T10/07-157 revision 2

Subject: SAM-4: Changes requested from 03/2007 editing session

During the SAM-4 editing session in March it was requested that the UML diagrams be enhanced to include all the parameters that are listed in the Execute Command procedure call and to add in associations between some of the classes in the SCSI initiator device and the logical unit class diagrams. This proposal makes those changes.

Figure 2 — SCSI Domain class diagram overview

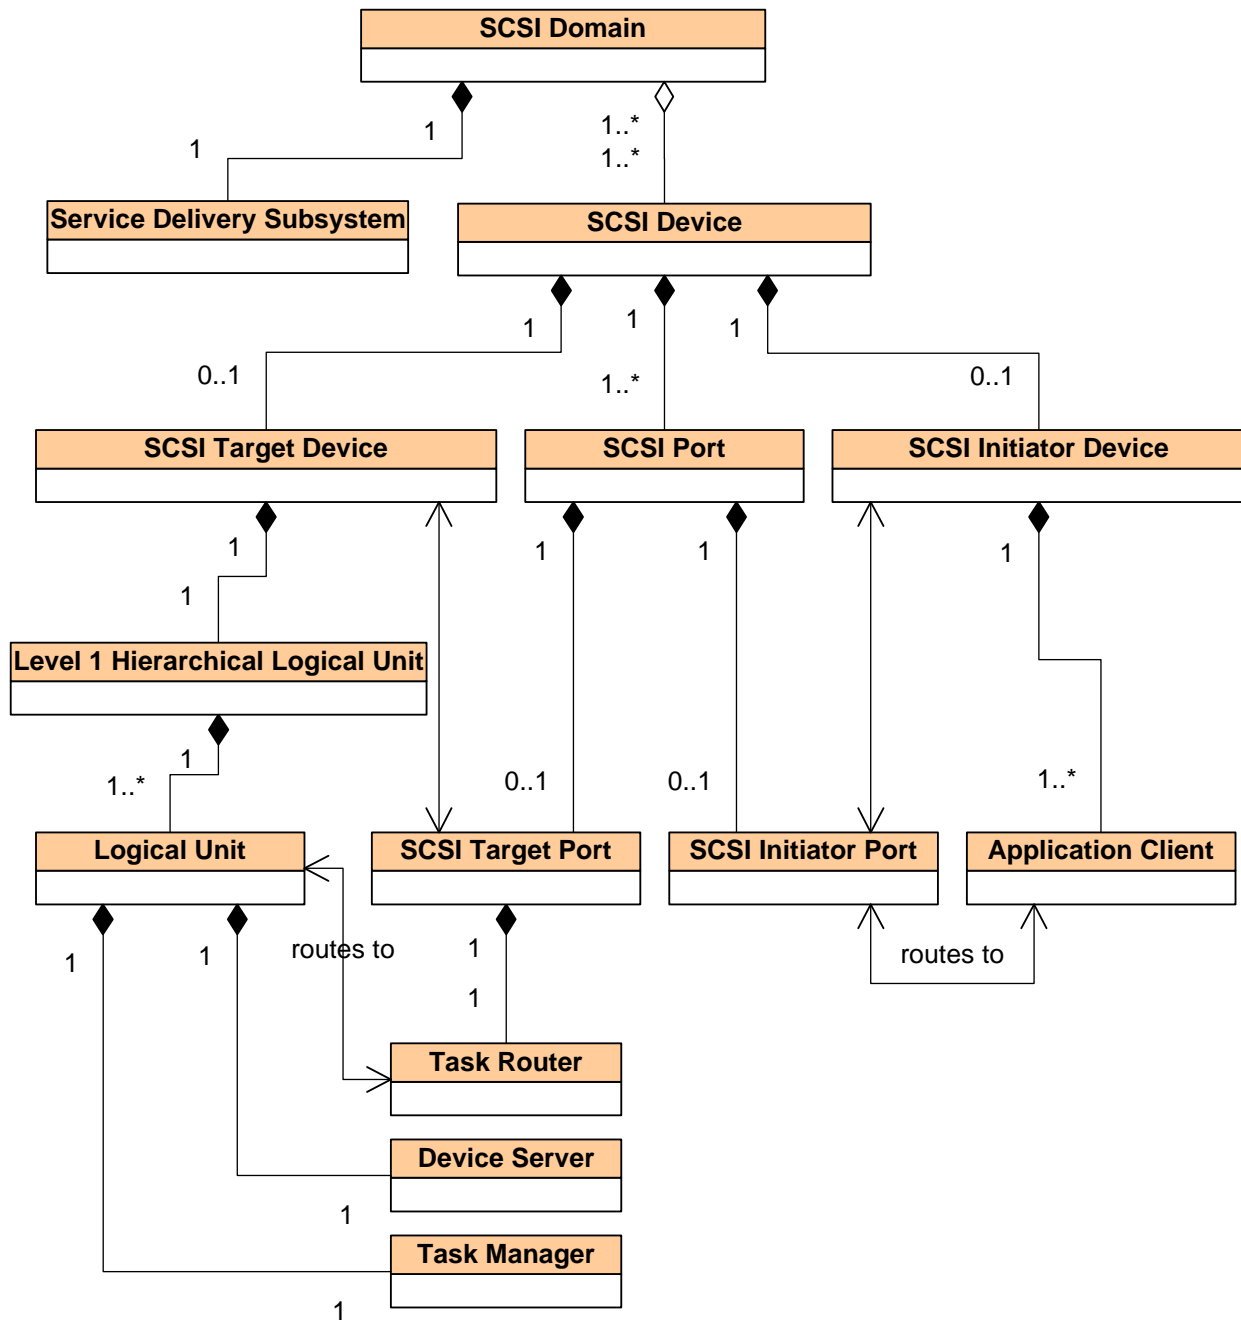
Figure 2 shows the main functional classes of the SCSI domain. This standard defines these classes in greater detail.

Figure 3 — SCSI Port class diagram

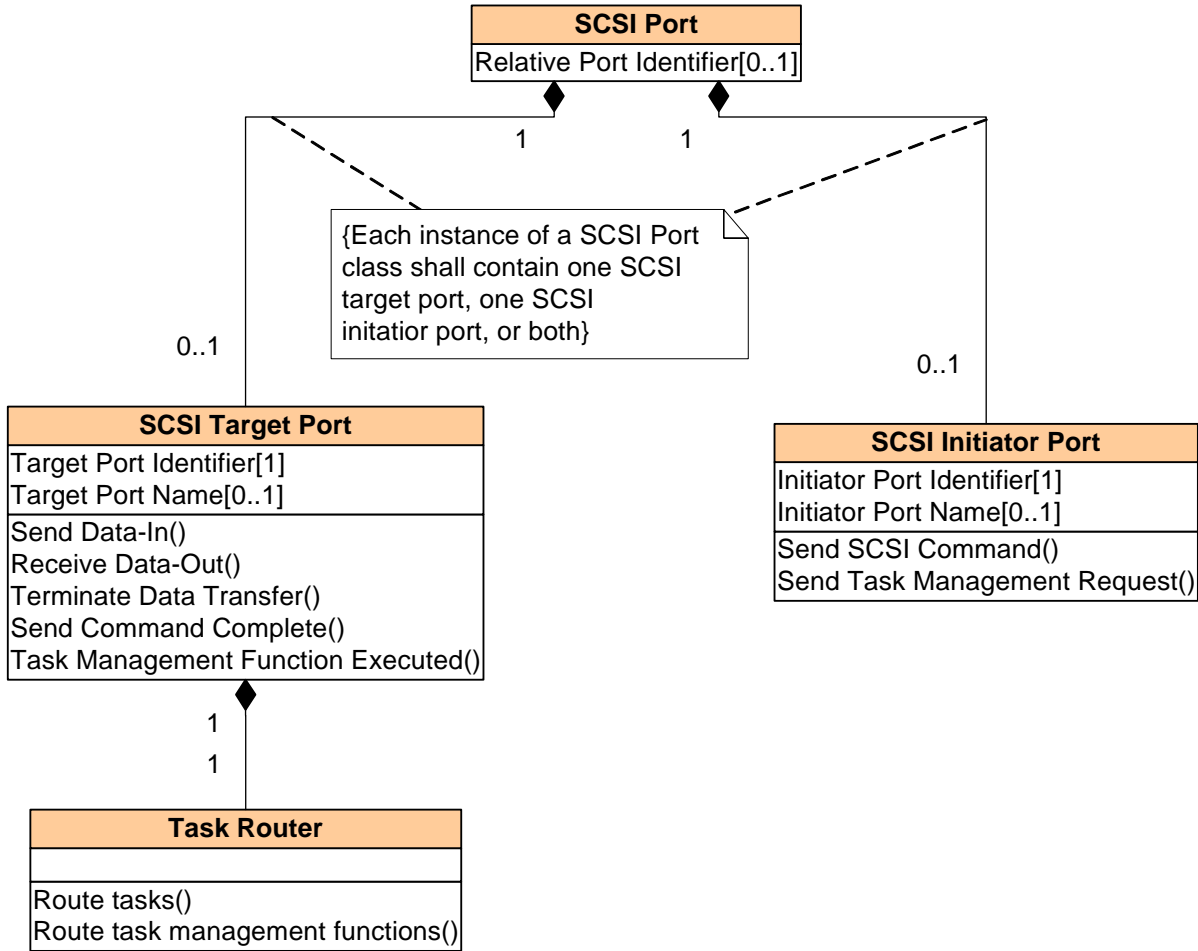
A SCSI Port class (see figure 3) contains the:

- a) SCSI Target Port class (see 4.4.3) that contains the:
 - A) Task Router class (see 4.4.5);
 - b) SCSI Initiator Port class (see 4.4.4.1); or
 - c) both.

Figure 4 — SCSI initiator device class diagram

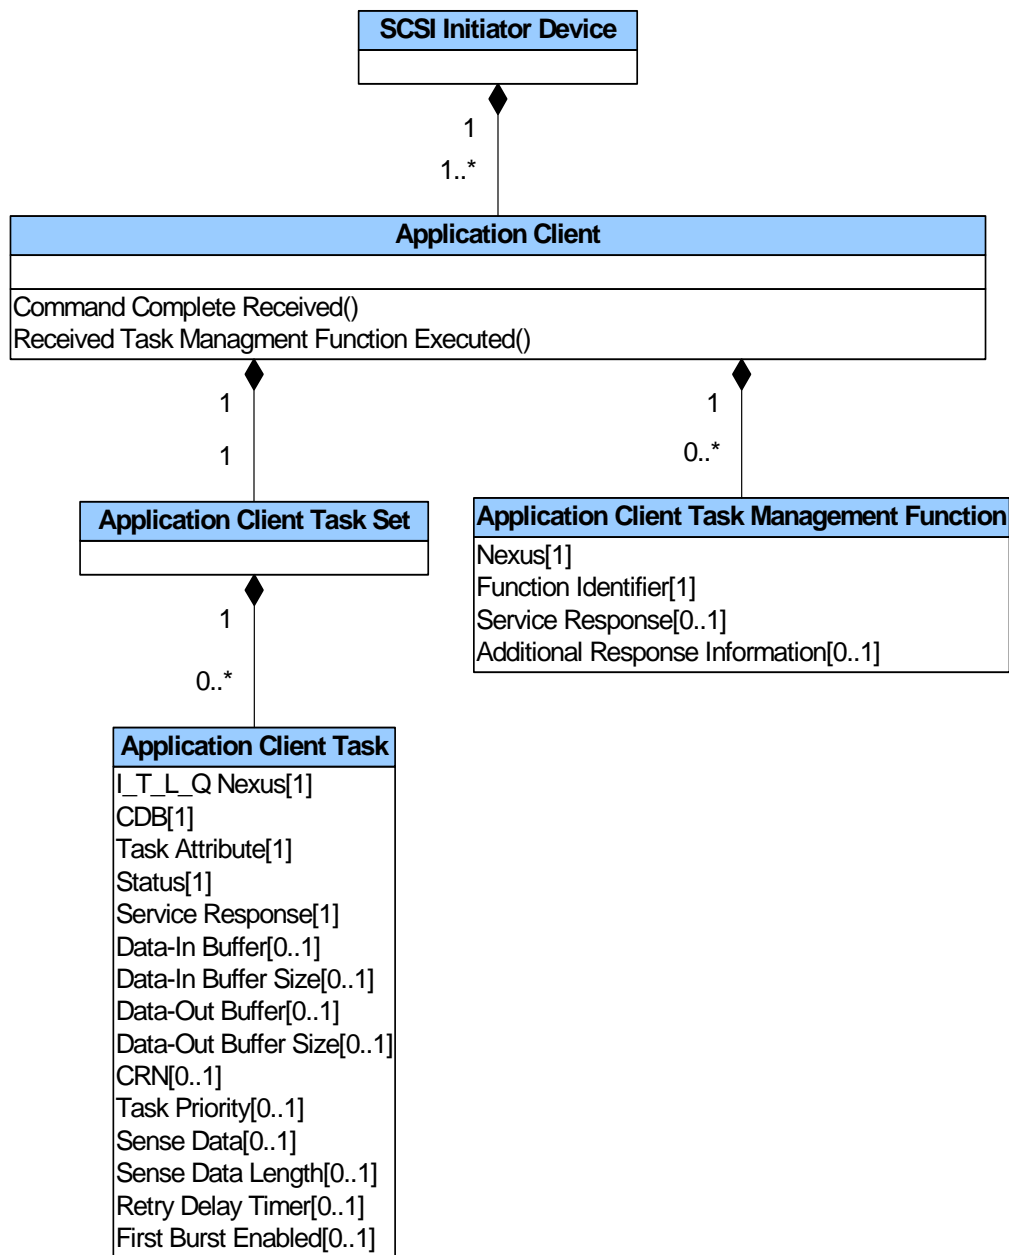
[A SCSI Initiator Device class \(see figure 9\) is a SCSI Device class that contains the:](#)

- a) ~~A SCSI initiator device-Application Client class (see figure 19)(see 4.5.10) is a SCSI device class~~ that contains the:
 - A) [Application Client Task Management Function class \(see xx.x.x\)](#); and
 - B) Application Client [Task Set class \(see 4.5.10\) that contains the:\(see 4.5.12\).](#)
 - ~~C) application-client task class (see 4.5.11).~~

Figure 5 — Logical unit class diagram

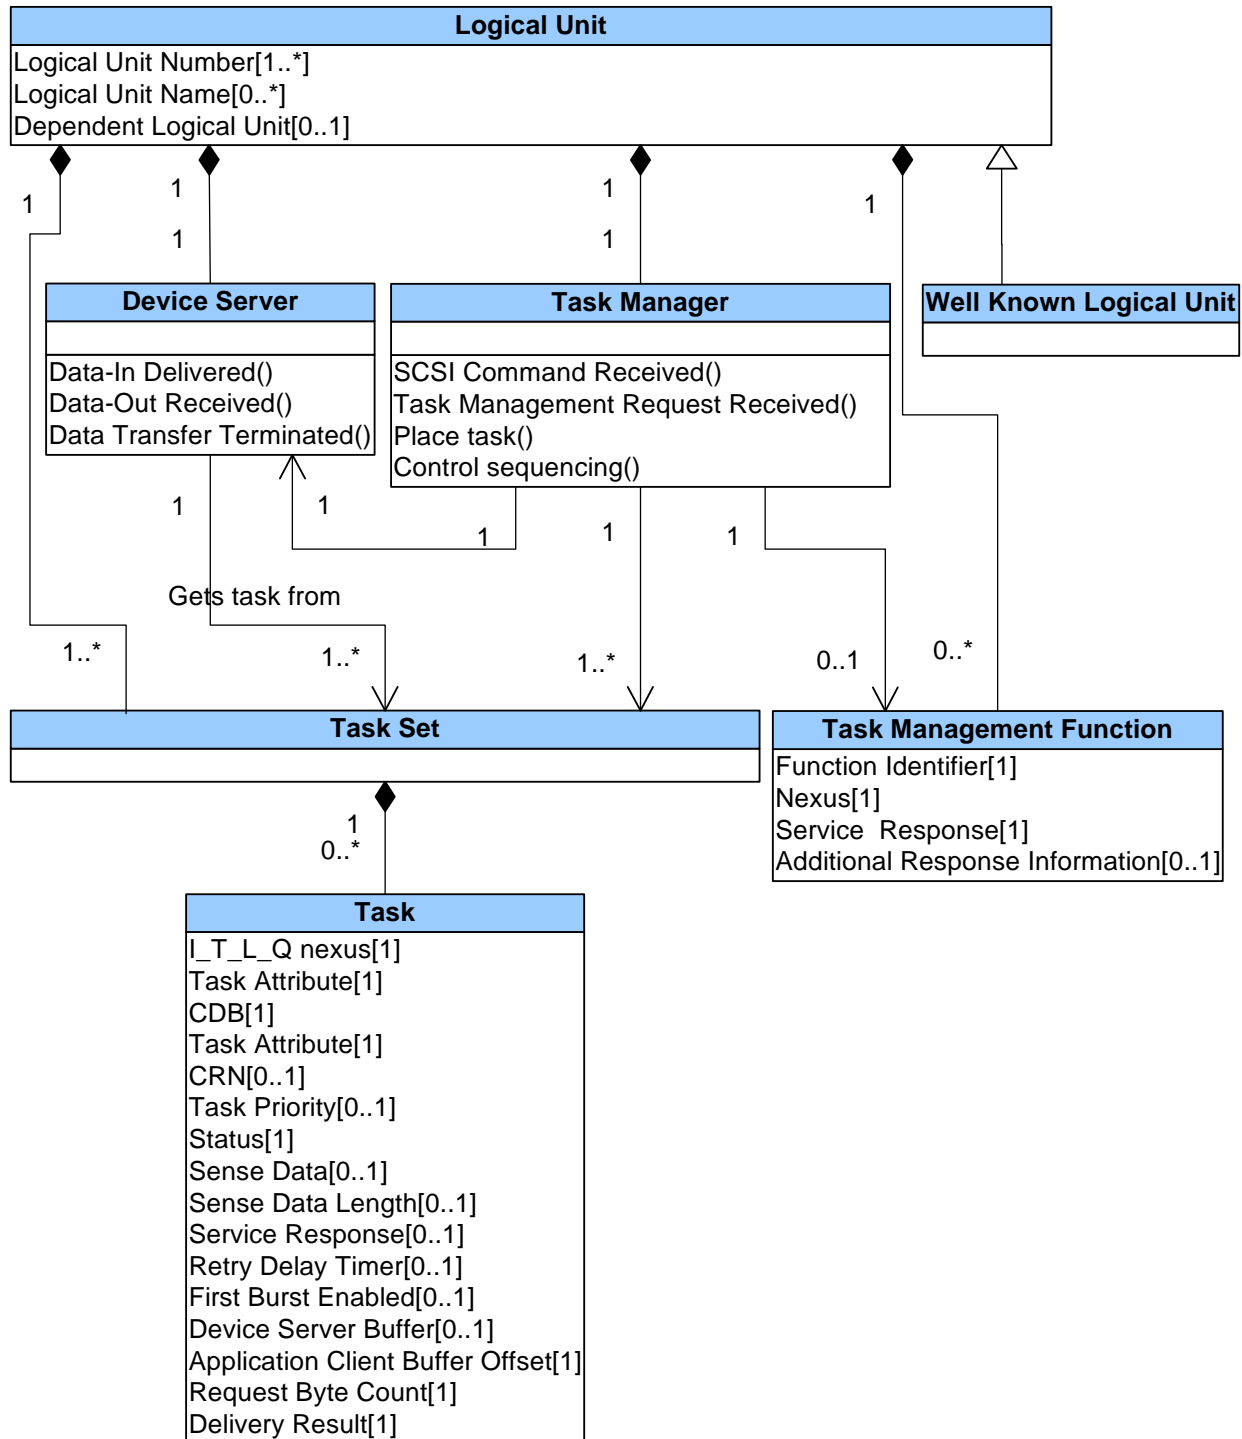
A Logical Unit class (see figure 13) contains the:

A Logical Unit class (see figure 13) may be substituted with the:

- a) Well Known Logical Unit class (see 4.5.24.1); or
- b) Hierarchical Logical Unit class.
